PRELIMINARY DRAINAGE REPORT FOR TRIPLE H RANCH - PRELIMINARY PLAN

CCES
Responses

PCD Project No. SP254

TRIPLE H RANCH - PRELIM. PLAN
PRELIMINARY DRAINAGE REPORT
PRE-DEVELOPED CONDITIONS
2604.00
SHEET 1 OF 2

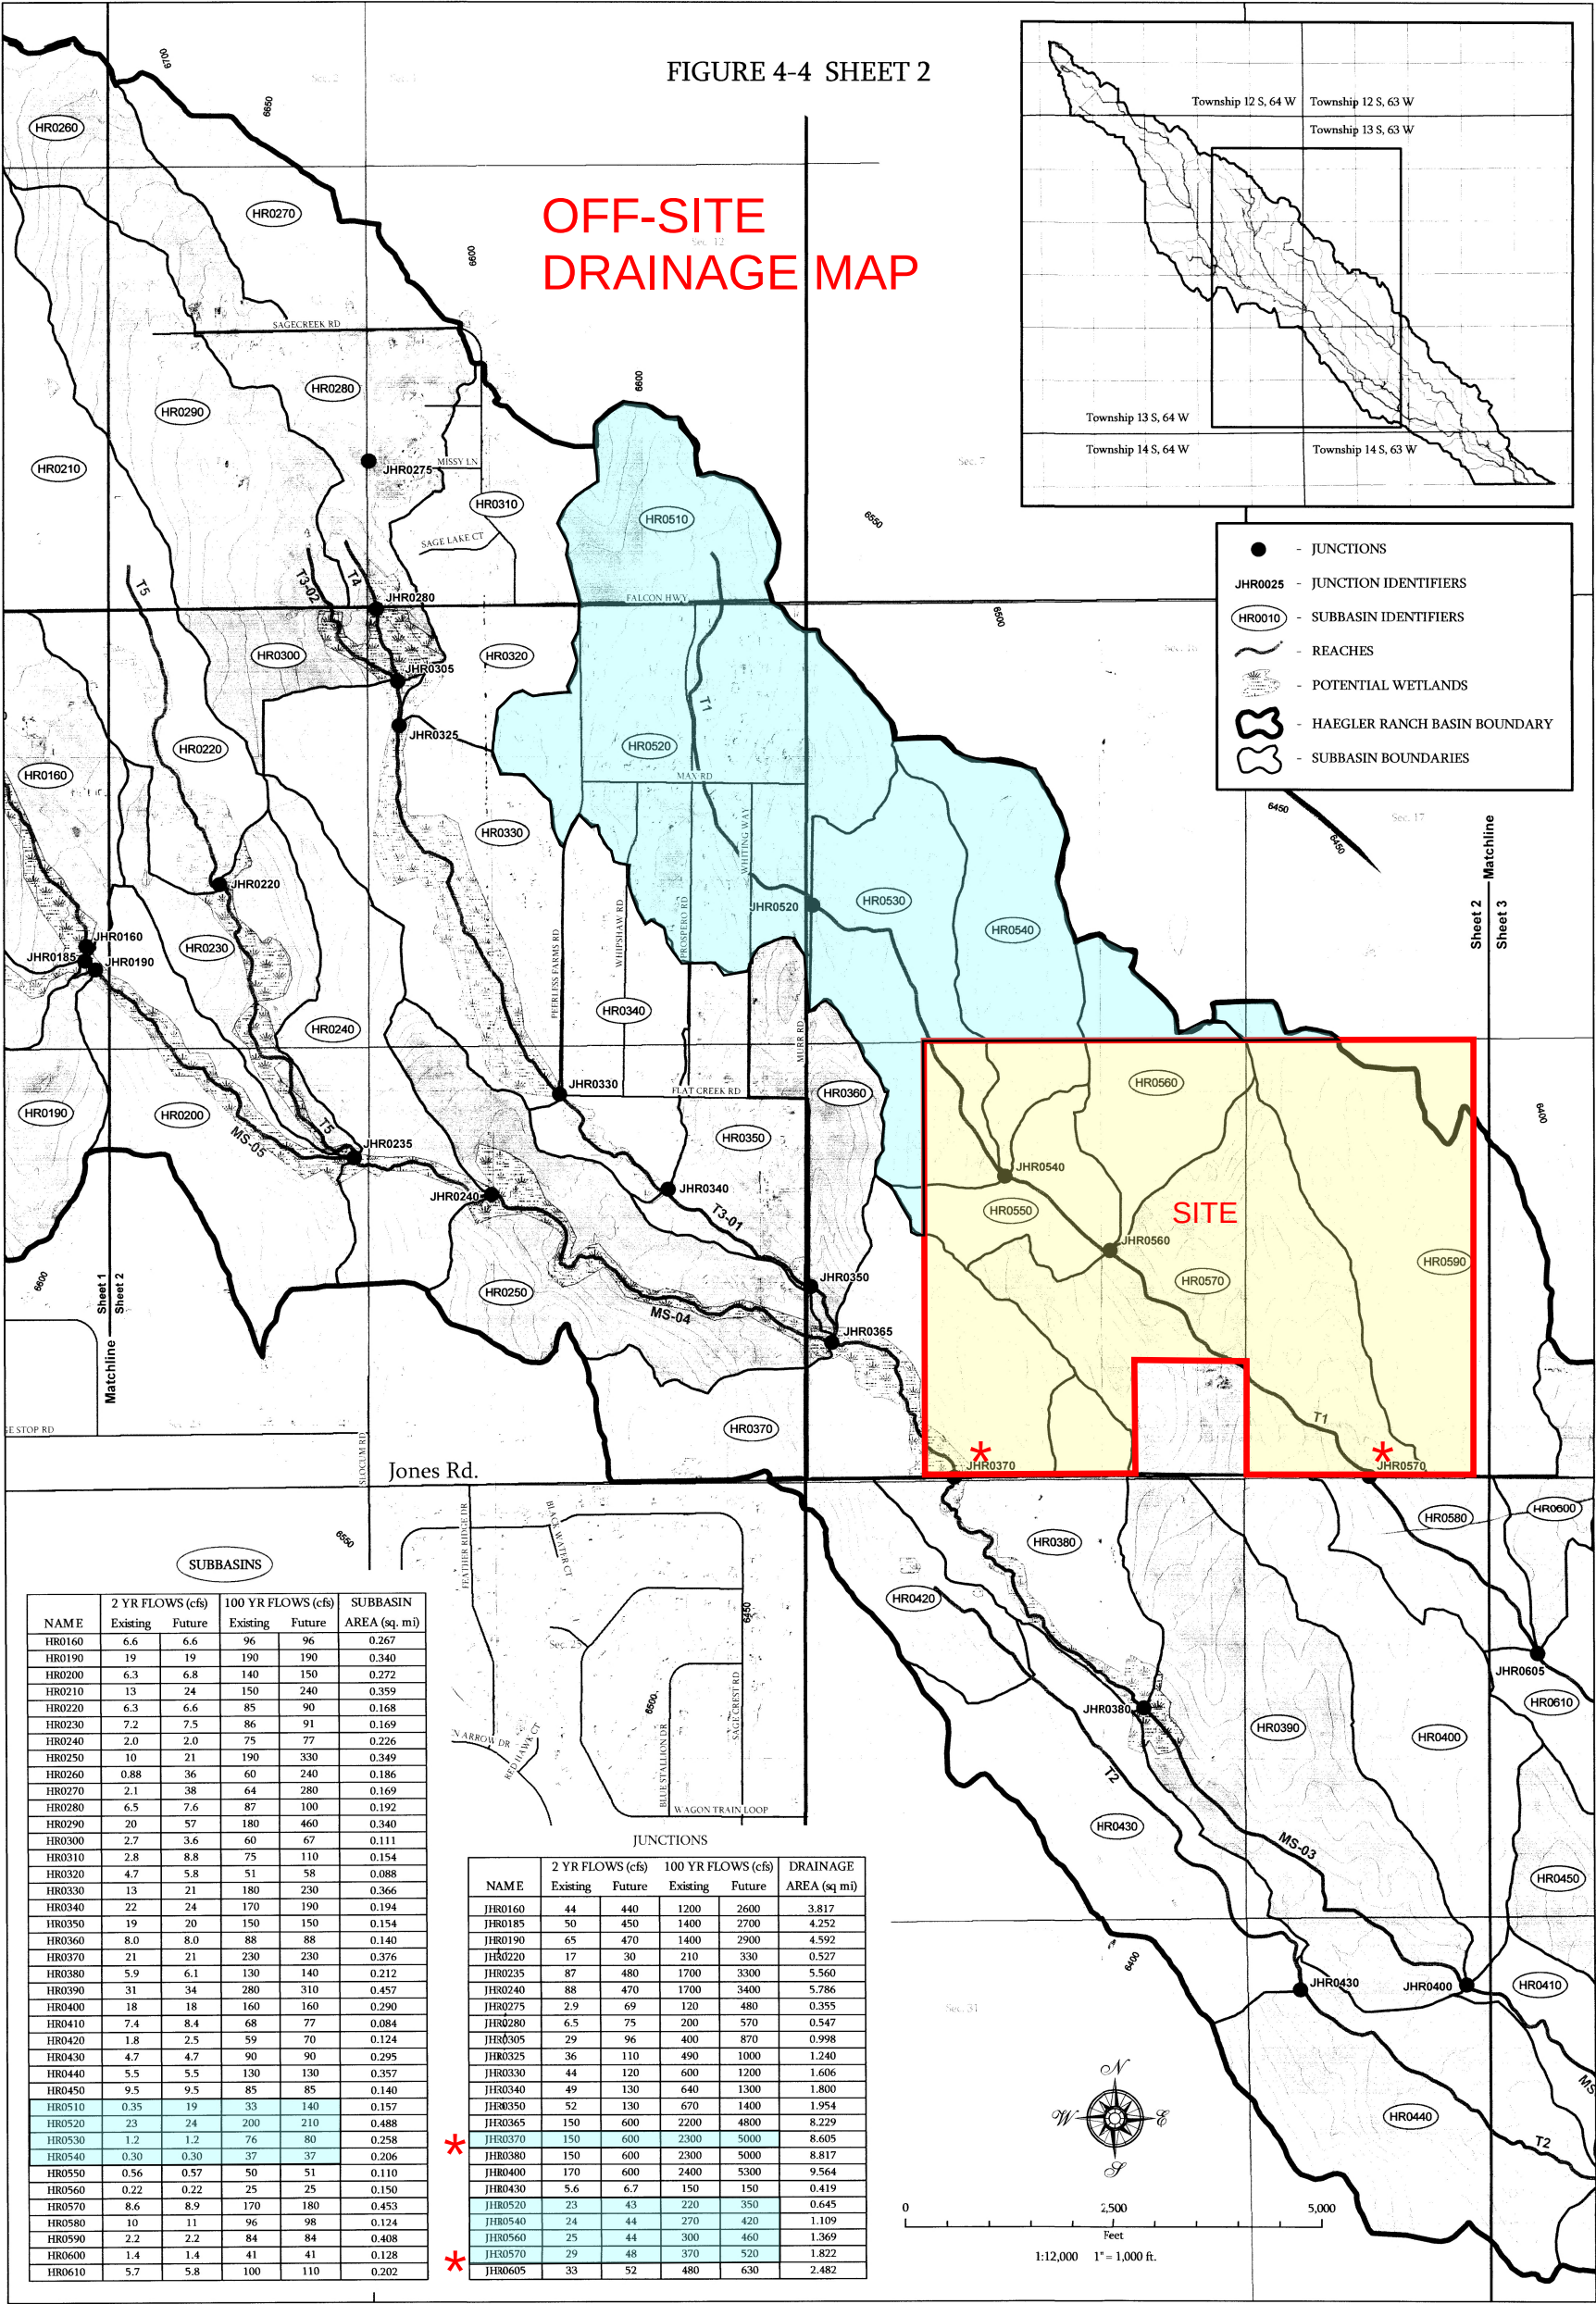
Unresolved: Need to show how flows are being conveyed off-site (all locations) & discuss suitable outfalls within report (See areas designated with *).
